Update Figure 33-14

IEEE802.3bt

Sep 2015

Yair Darshan

Figure 33-14: Current IEEE802.3 D1.2

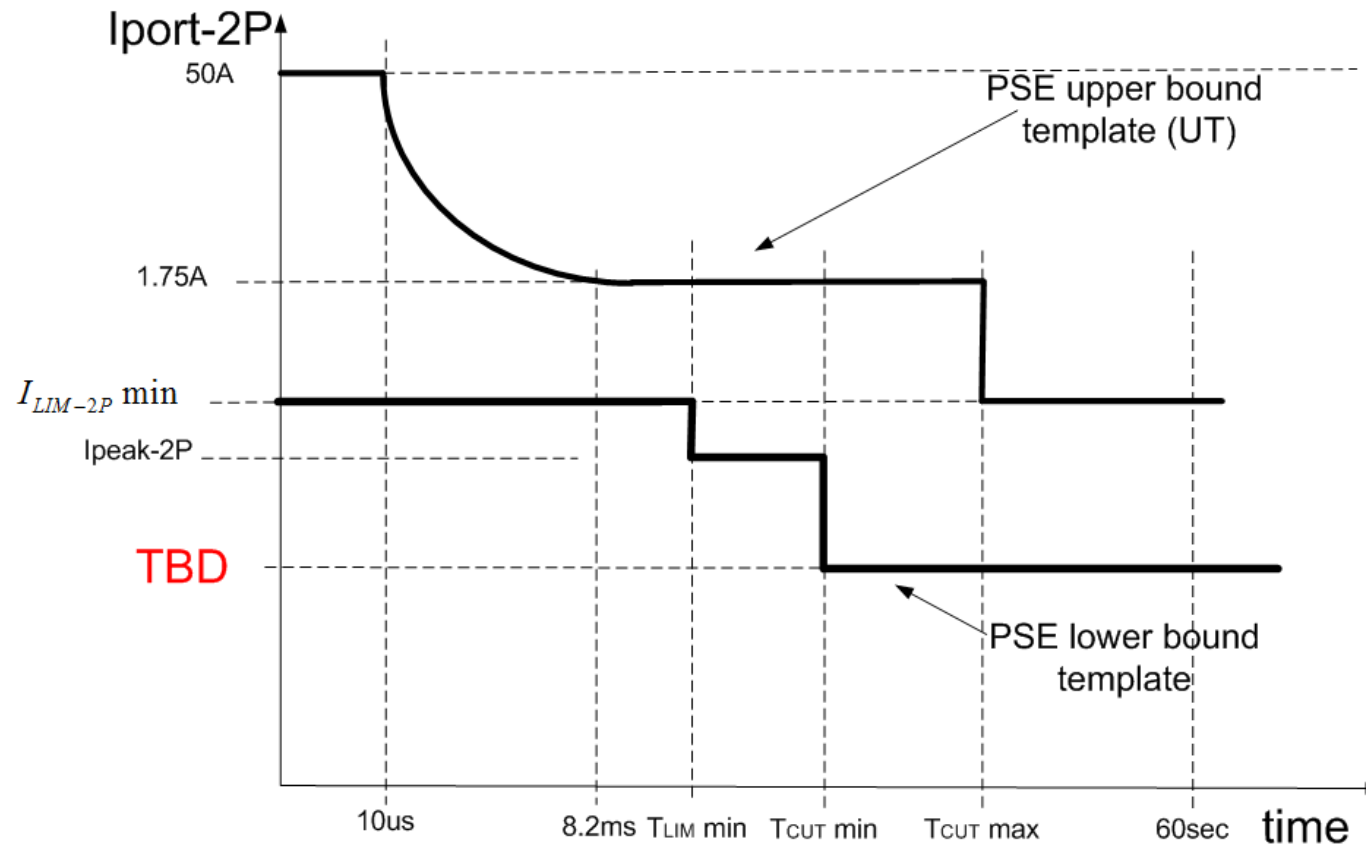
- The TBD we need to address

The TBD we need to address is the long term lower bound current that PSE has to supply

The TBD is the lowerbound that PSE has to supply

Option	The TBD = I_{con-2P}	Notes
1	$K_{cut} * P_{class} / V_{port}$	Shows maximum I_{con-2P_unb} in terms of P_{class} / V_{port} as in Type 1 and 2
2	I_{con-2P_unb}	Max pair current
3	$(I_{con} - I_{con-2Pmin})$ to I_{con-2P_unb}	A range of currents from I_{min} to I_{max}
4	$\min(I_{con} - I_{con-2P}, I_{con-2P_unb})$	Equation form that describes the actual value to be supported. With the constraints of I_{con-2P_unb} . (see Lenart's presentation)

Figure 33-14 for Type 3 (Type 4 is almost similar)

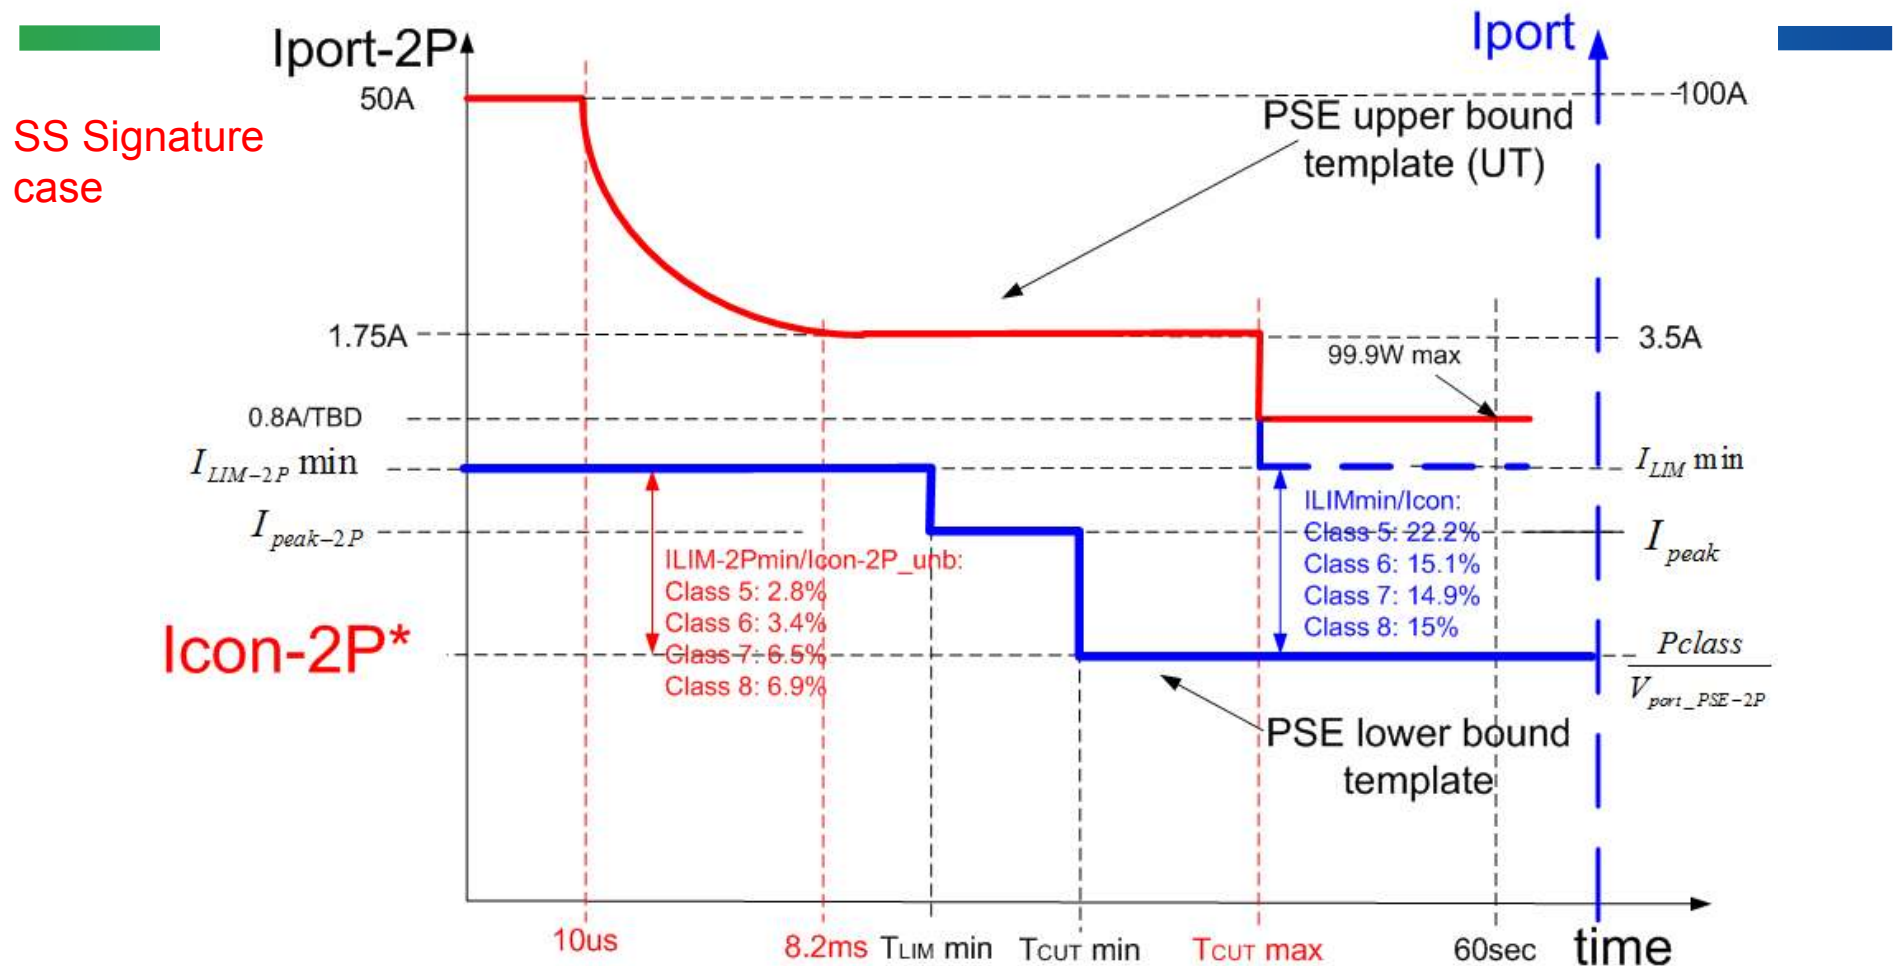
If the TBD is Icon-2P_unb what it means?

- Does it means that I need to supply $2 \times I_{\text{con-2P_unb}}$?

No! it means that your protections are set at $I_{\text{con-2P_unb}}$ or above and you will supply up to total Icon current

$I_{\text{con-2P}}$ can vary between $I_{\text{con}} - I_1$ to $I_{\text{con-2P_unb}}$ were I_1 it the other pair current.

$I_{\text{con-2P}}$ is equal to $I_{\text{con-2P_unb}}$ at the worst case.

The total current that PSE has to support is Icon and not $2 \times I_{\text{con-2P_unb}}$.

$I_{\text{con-2P}} = \min(I_{\text{con}} - I_1, I_{\text{con-2P_unb}})$.

(*) I_{con-2P} can vary between $I_{con} - I_1$ to I_{con-2P_unb} where I_1 is the other pair current. I_{con-2P} is equal to I_{con-2P_unb} at the worst case. The total current that PSE has to support is I_{con} and not $2 \times I_{con-2P_unb}$. The actual current on the pair set may be lower according to the following equation: $I_{con-2P} = \min(I_{con} - I_1, I_{con-2P_unb})$.

Optional combined Figure 33-14 for Type 1,2,3

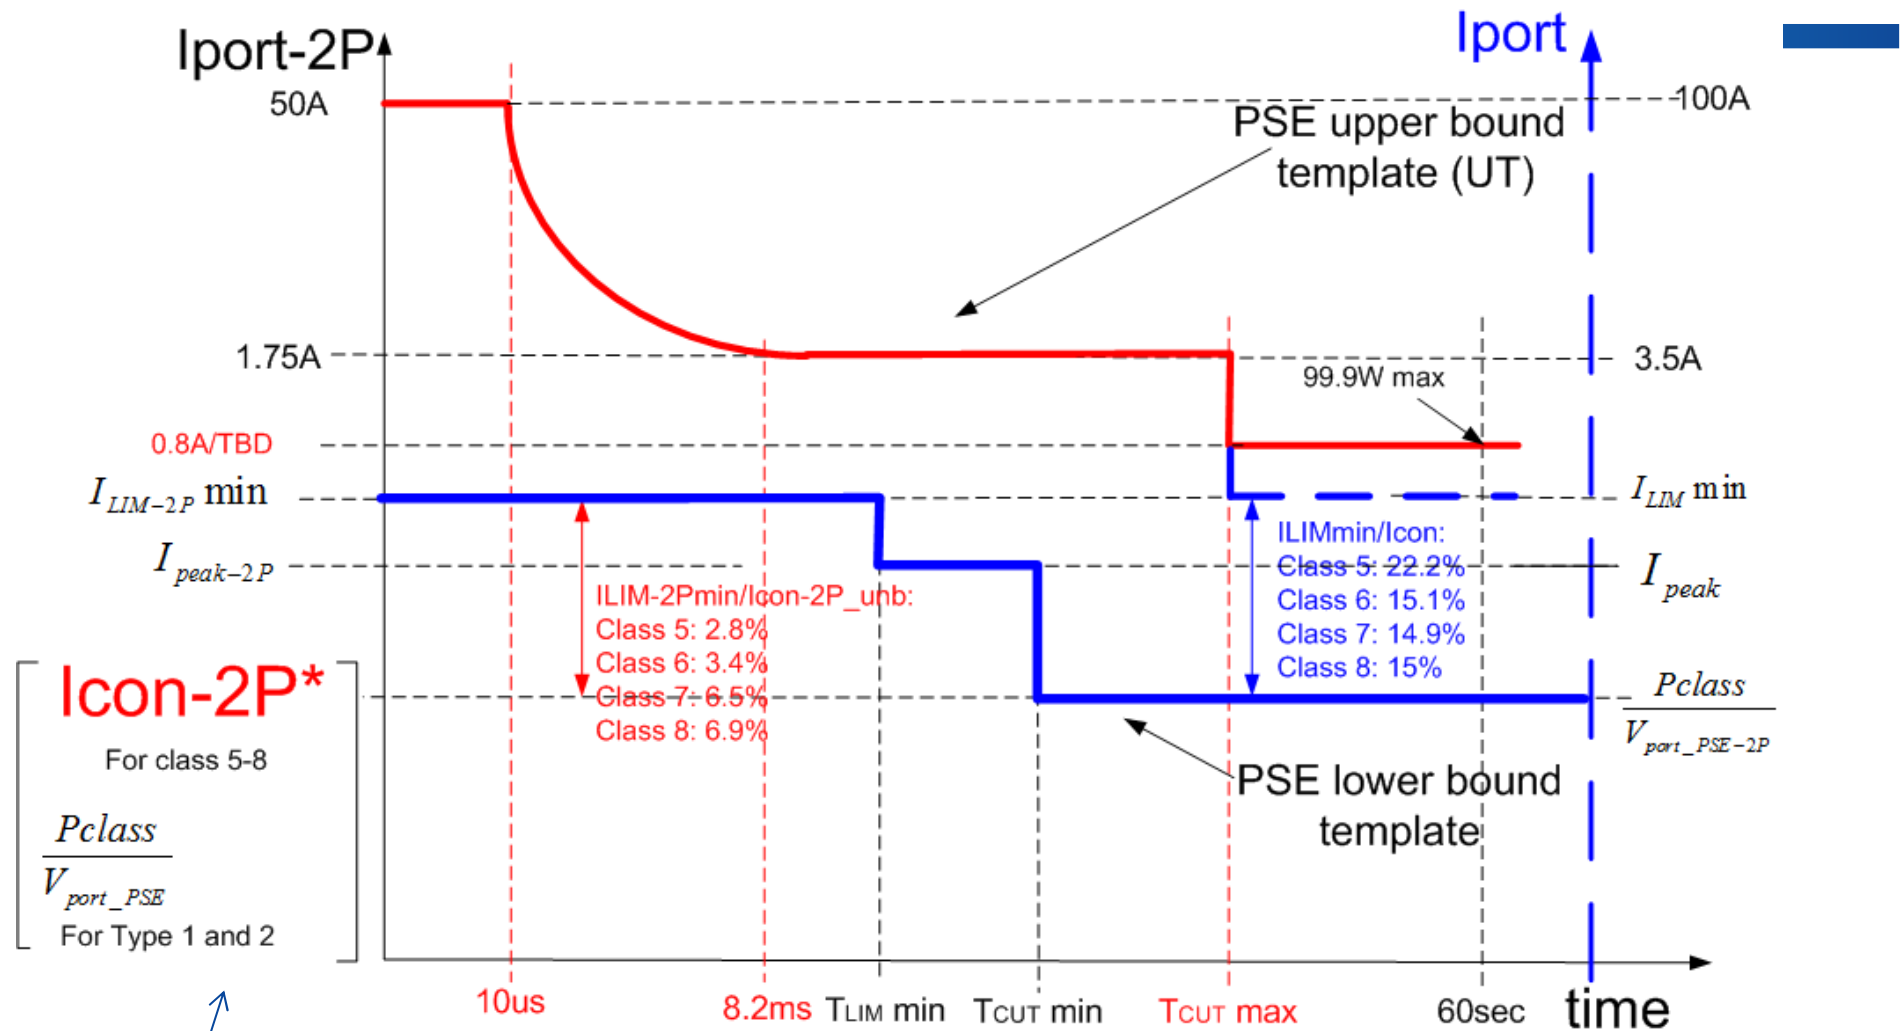
The TBD

- To verify that Type 4 can use the same drawing as Type 3 or different drawings are required.
